United States
Department of Defense

Better Contract Oversight Could Have Prevented
Deficiencies in the Detention Facility in
Parwan, Afghanistan

SUBJECT: Better Contract Oversight Could Have Prevented Deficiencies in the Detention Facility in Parwan, Afghanistan (Report No. DODIG-2012-089)

Figure 1. Examples of Poorly Welded Cell Grates

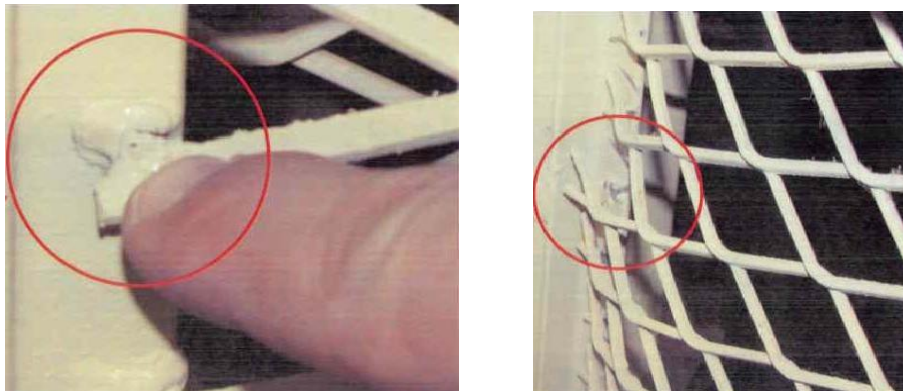
Cell doors were poorly constructed and hung with incorrect hinges, and access doors were missing the magnetic sensors and electronic locks. The contract called for the cell doors to be extra heavy duty, factory fabricated in accordance with American National Standard Institute A250.8 and National Association of Architectural Metal Manufacturers/Hollow Metal Manufacturers Association standards. Based on those standards the cell doors should have had welded frames and full-mortise heavy duty hinges complying with American National Standard Institute/Builders Hardware Manufacturer Association 156.1, spaced appropriately with a minimum of three hinges per door. The cells were to have a wire cage on the front and the doors equipped with all required commercial quality tamper proof hardware complying with applicable portions of American National Standard Institute /Builders Hardware Manufacturer Association standards A156 through A156.24 including closers on personnel doors of Series C02000, Grade 1 adjustable surface mounted type in accordance with American National Standard Institute /Builders Hardware Manufacturer Association Standards A156.4.

In a Construction Quality Presentation in July 2010, Task Force Rocky Mountain officials stated that the construction quality was not up to the standard suitable for a detention facility, and that the quality of construction of greatest interest was the areas where the detainees spent most of their time such as detention cells and the recreation yard. The presentation went on to say that the poorly constructed cell doors allowed detainees to damage the doors easily by repeated kicking. Figure 1 shows examples of the poor welding and Figure 2 shows the damage to the cell doors caused by the detainees because of the poor construction.

The poorly constructed cell doors allowed detainees to damage the doors easily by repeated kicking.

Figure 7. The Electrical System Panel (left) and Explanation of the System (right)

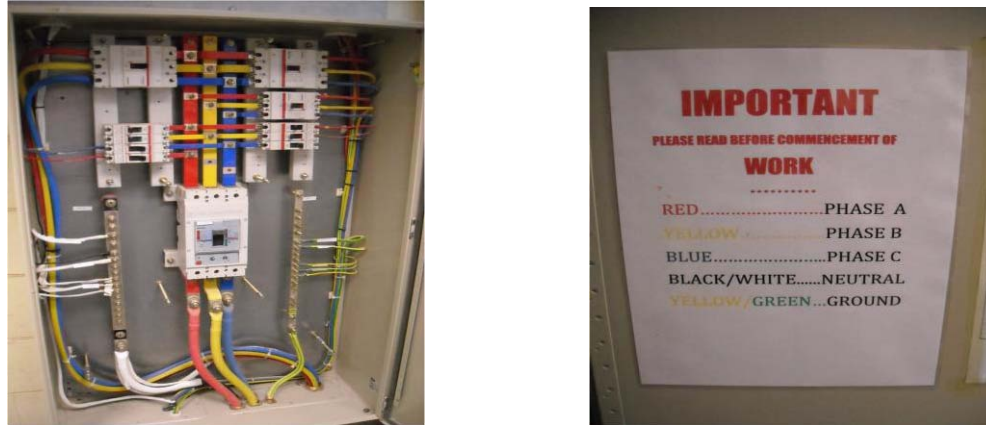
Personnel who had experience with the British Standard installed the British Standard electrical system during construction, and posted the explanation of the British Standard inside the electrical panels (see figure 7 [right]).

Continued failure to correct the electrical code violations increases the risk of loss of service and the potential of the loss of life for anyone attempting repairs.

Comment: USACE has previously advised that the electrical system was built to US standards with some British equipment. However, the report states that the system is built "primarily to British standards" and that this was done without approval. The voltage system for the DFIP is US (60 Hz) while the color coding in place is British due to the British materials used for this project. It should also be pointed out that even if the system were built to British standards, this would still be in accordance with USFOR-A policy and USACE Transatlantic Division guidance.

Comment: This statement appears to be based on a USACE deficiency report from June 25, 2010, however all grounding and bonding issues were subsequently corrected under warranty.
